**PLANNING COMMISSION HEARING DATE: APRIL 5, 2018
AGENDA ITEM NO.: 2**

Case Numbers	P14-1033 (Design Review), P14-1034 (Lot Line Adjustment)	
Request	To consider an appeal of an approval by the Development Review Committee for a proposal by Art Day of Transition Properties, L.P. for a Design Review to construct a 308,000 square foot warehouse building, a Lot Line Adjustment to consolidate four parcels into one parcel, and related Mitigated Negative Declaration and Mitigation Monitoring and Reporting Program.	
Applicant	Karen Renfro on behalf of the Springbrook Heritage Alliance	
Project Location	3705-3667 Placentia Lane, located on the south side of Center Street, north side of Placentia Lane, between Orange and Main Streets	
APN	246-070-002, 246-070-017, 246-040-027, 246-040-028	
Project area	15.9 acres	
Ward	1	
Neighborhood	Northside	
General Plan Designation	B/OP – Business/Office Park	
Zoning Designation	BMP – Business and Manufacturing Park Zone	
Staff Planner	Brian Norton, Senior Planner; 951-826-2308; bnorton@riversideca.gov

Development Review Committee Memorandum

Case Numbers	P14-1033 (Design Review), P14-1034 (Lot Line Adjustment)	
Request	To consider a Design Review of

SHEET: A1-2P

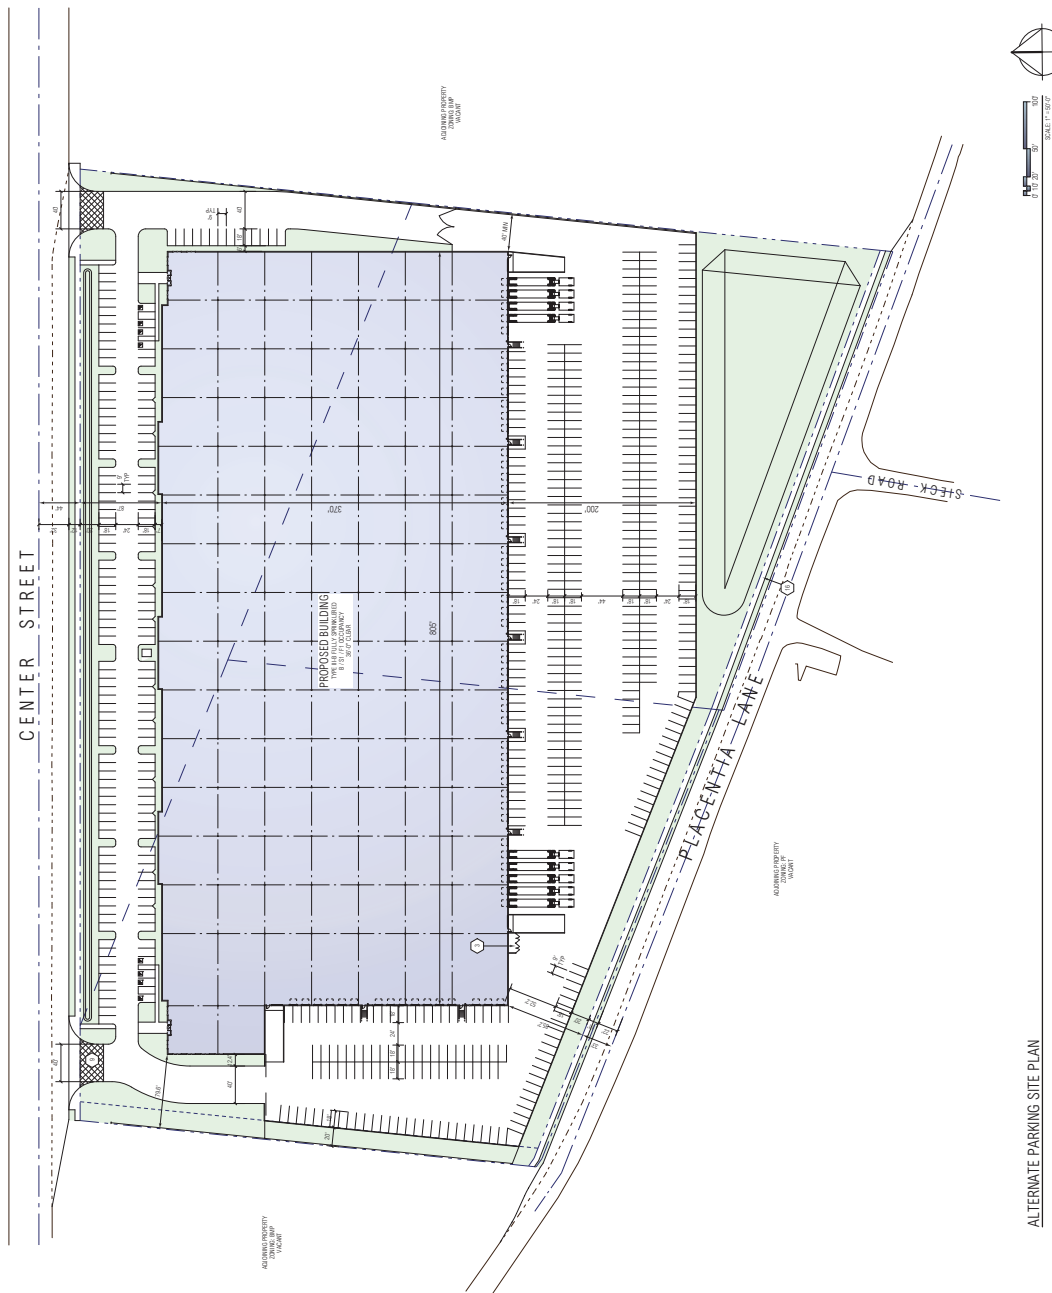
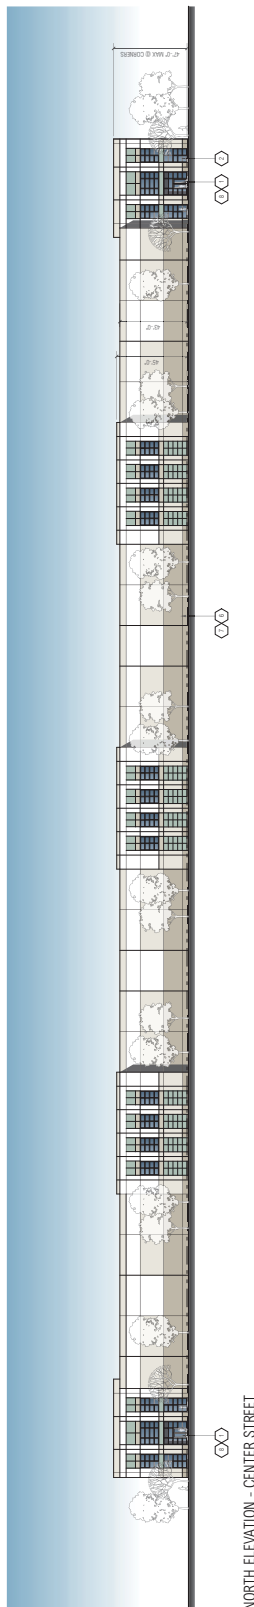
Staff has added conditions recommending 'returns' be added to office tower elements and panel sections that protrude higher than the main roof line adding visual interest and greater articulation. Additionally, staff recommends the westerly most south facing wall be enhanced and finished similar in architectural style to the office segments of the building. As conditioned, Staff supports the building elevations as they are consistent with recently constructed warehouse buildings located throughout the City and are consistent with the Citywide Design Guidelines.

19. **Staff Required Building Elevation Conditions:** Revise submitted building elevations such that the plans provided for building permit plan check incorporate the following changes;

- a. Where building walls protrude higher than the main roof line, returns shall be added.
 - b. The westerly most south facing wall be enhanced and finished similar in architectural style to the remainder of the building
